TRANS/SC.3/WP.3/2005/5 21 March 2005

# FURTHER UPDATING OF THE EUROPEAN CODE FOR INLAND WATERWAYS (CEVNI)

Transmitted by the Government of Belarus, the Danube Commission and the secretariat

Article 3.32: Prohibition of smoking or using an unprotected light or flame.

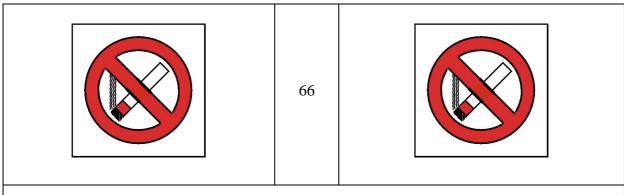
6. The Government of Belarus proposes amending the text of article 3.32 (1) (b) in TRANS/SC.3/2004/6, describing boards marking the prohibition of smoking or using unprotected light or flame, as follows:

"circular white boards bordered with red, with a red diagonal strip **across a picture of** a cigarette emitting smoke".

13. The Government of Belarus proposes modifying sketch 66 (Annex 3 in TRANS/SC.3/2004/6) to put the red diagonal stripe across the picture of the cigarette emitting smoke.
